Vehicles With Back-Of-Cab SCR - Exhaust Stack Replacement Information, PM Sensor Failure Repair Information

Requested by Brett Bell, Spare Parts Engineering

There has been a change in the design of the vertical exhaust stack for vehicles built prior to mid-March (Week 11) 2018 with a back-of-cab SCR. This change addresses PM Sensor failures caused by water contamination.

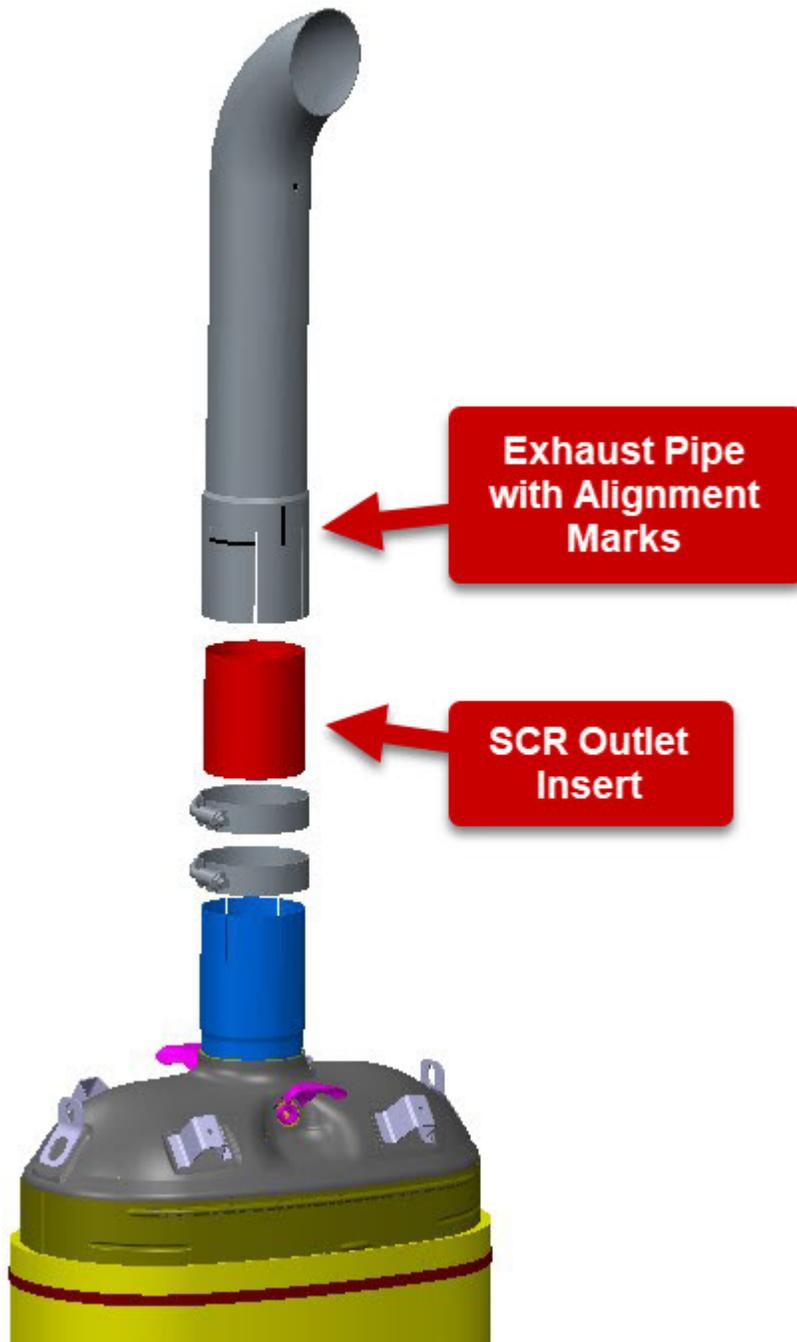
The solution introduces a two part configuration: a new exhaust pipe with alignment marks and an insert for the outlet of the SCR, shown in the diagram below.

Note that the old pipe is not compatible with this new configuration.

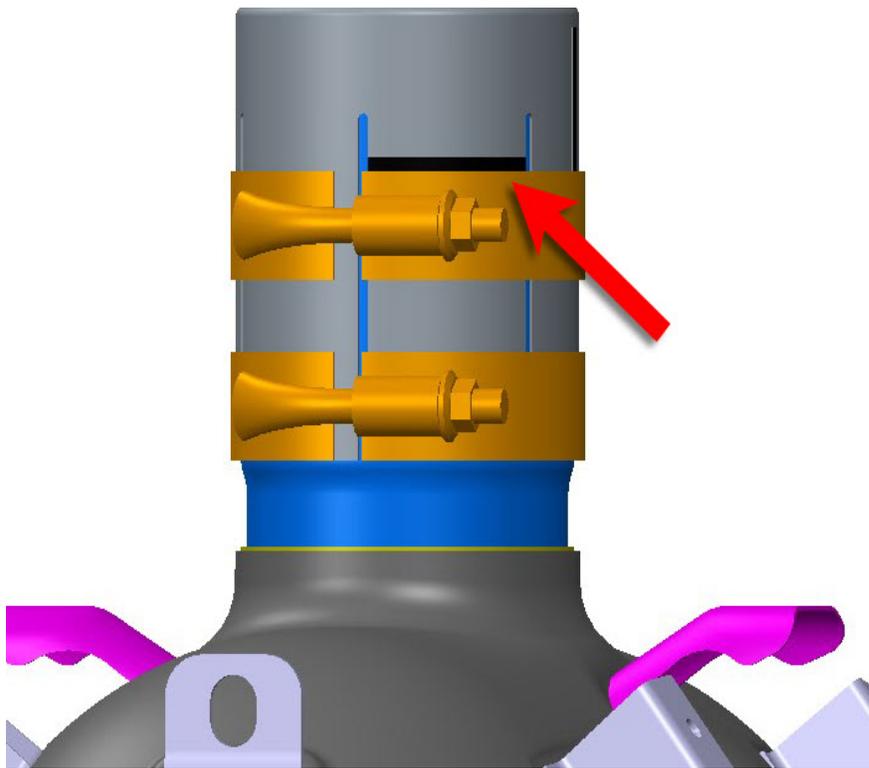
4. When installing the new exhaust stack:

- The top clamp should be aligned with the horizontal mark

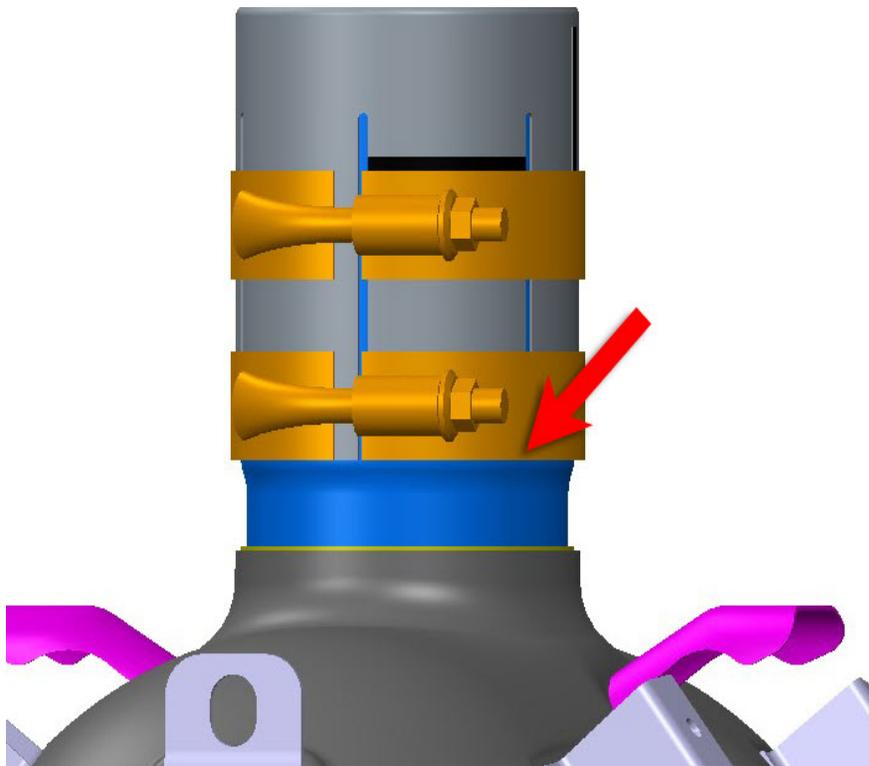
- The bottom clamp should be aligned with the bottom of the exhaust pipe.

- The vertical mark on the pipe should be aligned with the PM sensor boss on the SCR.
